Date: May 03, 2007

From: George Penokie (IBM)

Subject: SAM-4: Changes requested from 03/2007 editing session

During the SAM-4 editing session in March it was requested that the UML diagrams be enhanced to include all the parameters that are listed in the Execute Command procedure call and to add in associations between some of the classes in the SCSI initiator device and the logical unit class diagrams. This proposal makes those changes.

Figure 1 — SCSI initiator device class diagram

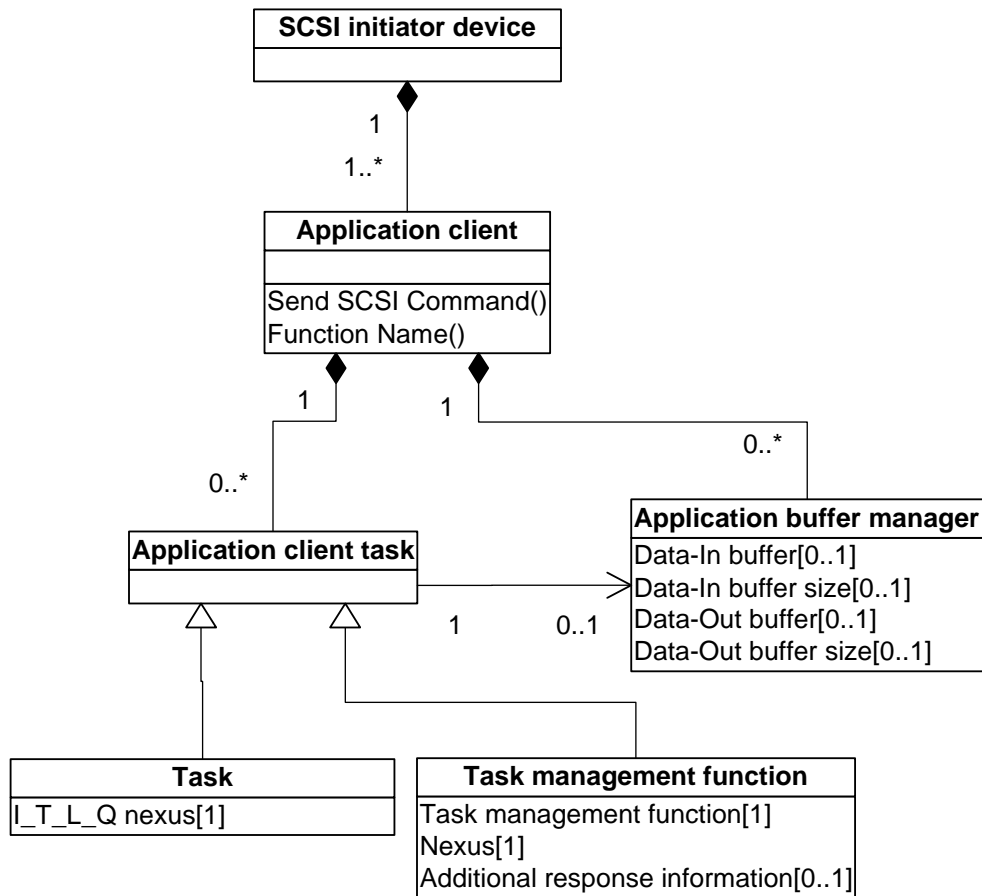
- a) ~~A SCSI initiator device application client~~ class (see figure 19)(see 4.5.10) is a SCSI device class that contains the:
  - A) application client ~~task~~ class (see 4.5.10) that contains the:(see 4.5.12); and
  - B) application ~~client task~~ ~~buffer manager~~ class (see 4.5.11)(see 4.5.11).

- a) one or more application clients that contain:
  - A) ~~one-zero~~ or more application ~~clients that contain:~~client tasks; and
  - B) zero or more application client ~~tasks~~buffer managers.

An application client class contains zero or more application client tasks and for each application client task zero or one application client buffer manager.

**Figure 2 — Task class diagram**

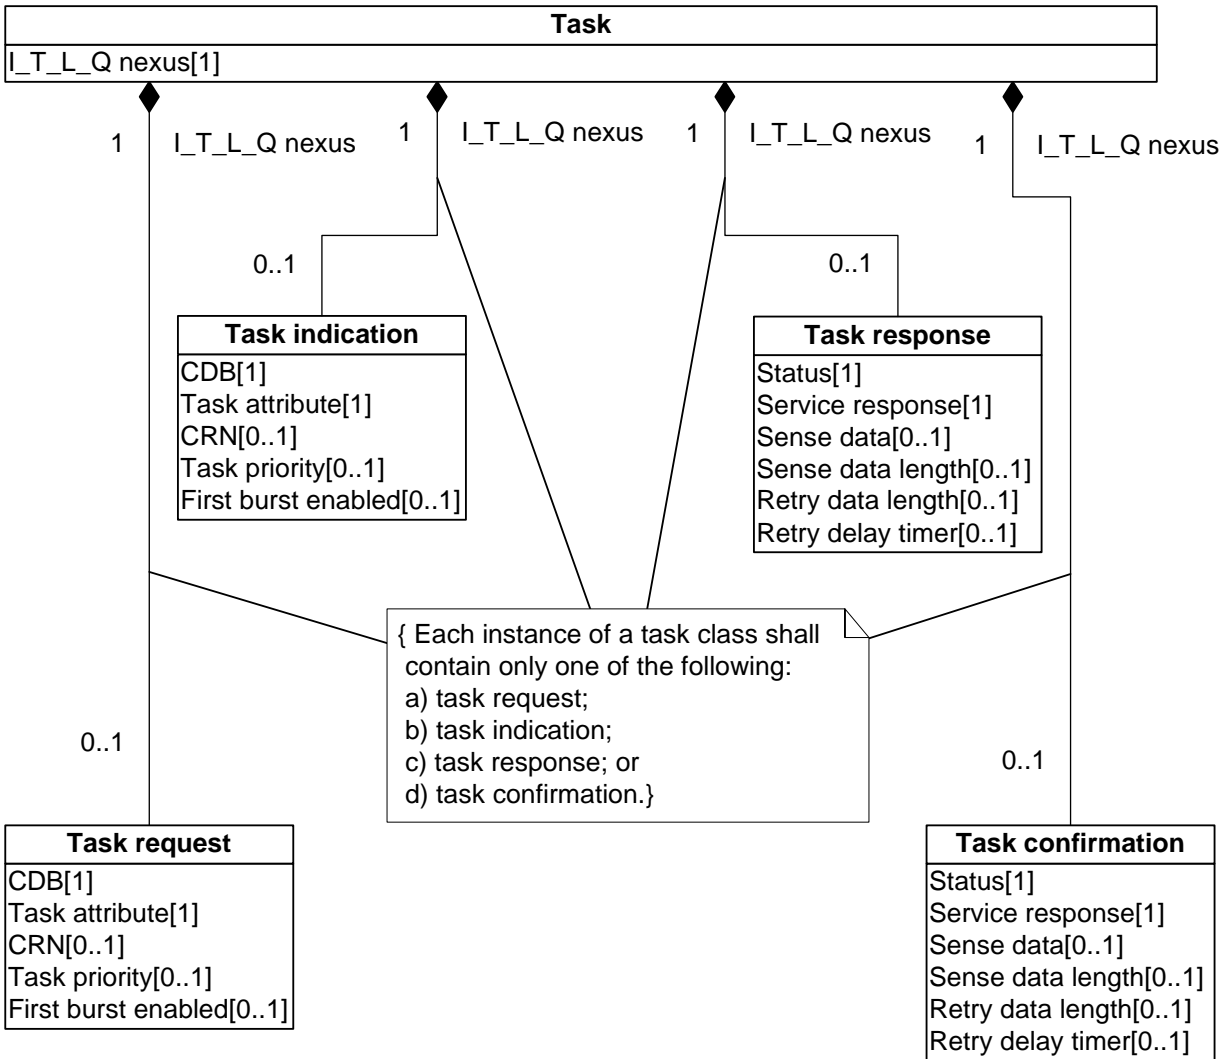
- a) task request class (see 4.5.15);
- b) task indication class (see 4.5.16);
- c) task response class (see 4.5.17); and
- d) task confirmation class (see 4.5.18).

- a) one task request;
- b) one task indication;
- c) one task response; or
- d) one task confirmation.

~~Each instance of a task class represents the work associated with a command.~~ A new command causes the creation of a ~~task~~ task class. The task class persists until a ~~task command~~ complete response confirmation is ~~sent received~~ or until the task is ended by a task management function or exception condition. For an example of the processing for a command see 5-75.7.

Figure 3 — Logical unit class diagram

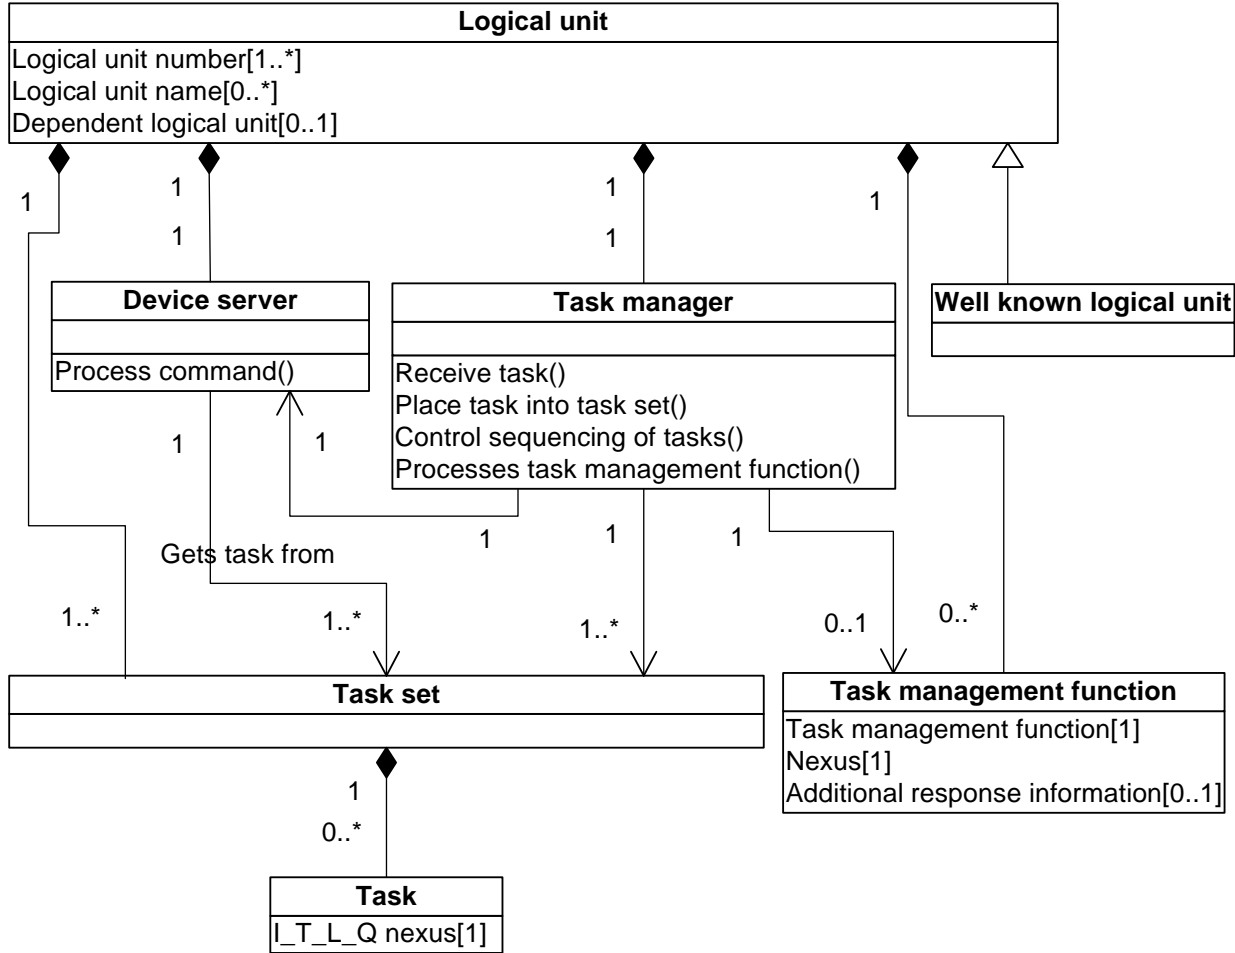
- a) device server class (see 4.5.25);
- b) task manager class (see 4.5.26); and
- c) task set class (see 4.5.27).

- a) well known logical unit class (see 4.5.24.1); or
- b) hierarchical logical unit class.

- a) one device server;
- b) one task manager; and
- c) one or more task sets.
